Subject: 20139 Mack Avenue (Ahee Jewelers) Variance Request
Parcel ID: 999-20-20139-00
Updated Site Plan Approved by Planning Commission July 25, 2023
Zoning: C - Commercial Business

We have reviewed the site plan and application submitted on June 13, 2023 and the updated site plan submitted on July 25, 2023 by Stucky Vitale Architects on behalf of Peter Ahee of Ahee Jewelers (the "Applicant"). The Applicant requested to construct a one-story addition to the existing retail store at 20139 Mack Avenue, demolish an adjacent retail building, and relocate a parking lot. The addition is to accommodate a display from the Patek Philippe Collection.

Proposed Layout (renderings from July 25 Site Plan):

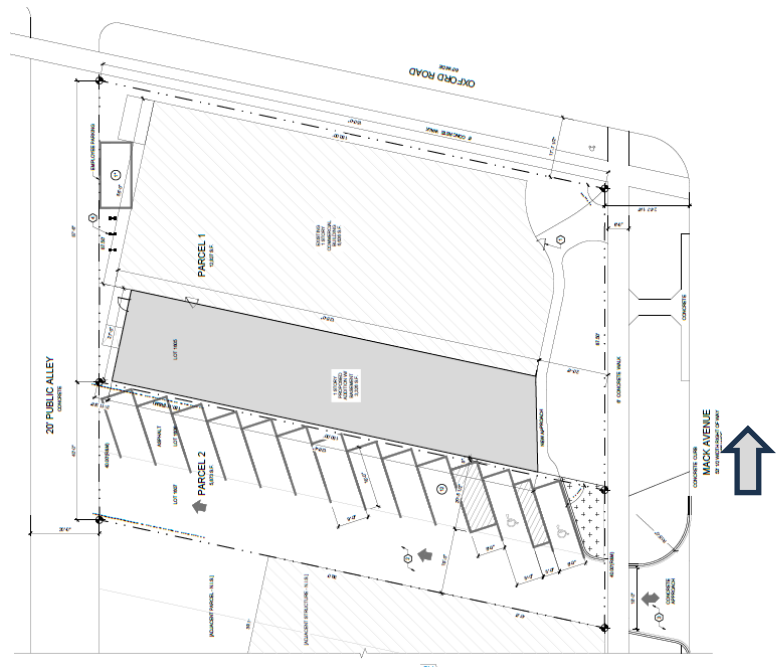
Planning Commission approved the updated site plan from July 25, 2023 (rendering seen below). This updated site plan addressed six (6) out of the seven (7) recommended changes made in the Planners Review letter from July 13, 2023. One change they were unable to accommodate was providing additional off-street parking spaces. Thus, a variance is needed to exempt the property from providing the required off-street parking as required by the Zoning Ordinance. Upon review of the proposed plan compared to the applicable ordinance standards, we offer the following comments and recommendation for your review.
